Answers to questions raised at demonstration of solar permit application improvements in Development Hub PDX
October 5, 2022

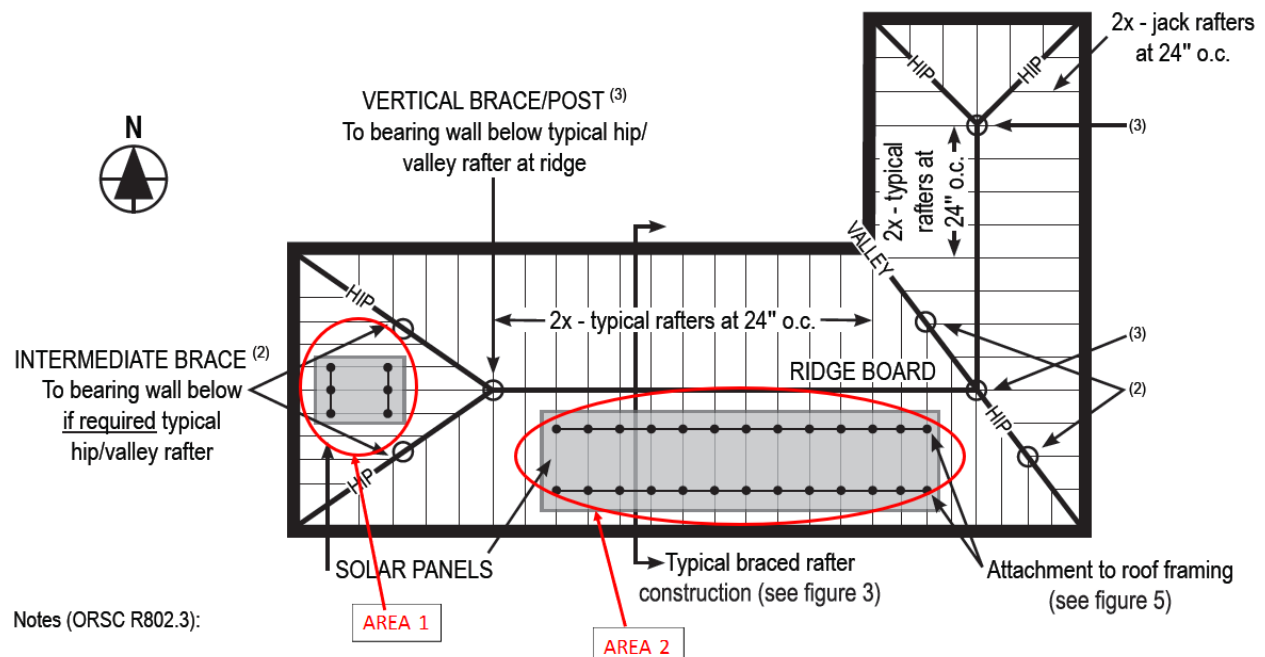
Question 1: If modules are over a trapezoid shaped roof, with hip/valley rafters are on the ends, however the modules are only covering full-length rafters, does it follow standard procedure as far as rafter spans and such and ignores the whole intermediary braces/posts at hip/valley points?

We are interpreting that the person is asking: If a roof has hips and valleys but solar panels are placed so that they do not impact the hips and valley framing, do they still need to check hips and valley framing? In general, one does not need to check the hips and valley framing if the hips and valley framing members are not impacted by the placement of the solar panels. The key word is “impacted.” Solar panels do not have to be directly over a valley or hip framing to be impacted. For example, the solar panels may be placed on the gable end that impacts the loads to the hip and valley framing even though the solar panels are not directly on a hip or valley member. In such a case hips and valleys need to be checked. As an example, see the figure below. If solar panels are placed in area 1 then hips and valley framing members need to be checked. If there are no panels in area 1 and solar panels are only in area 2, for example, then hips and valleys do not need to be checked.
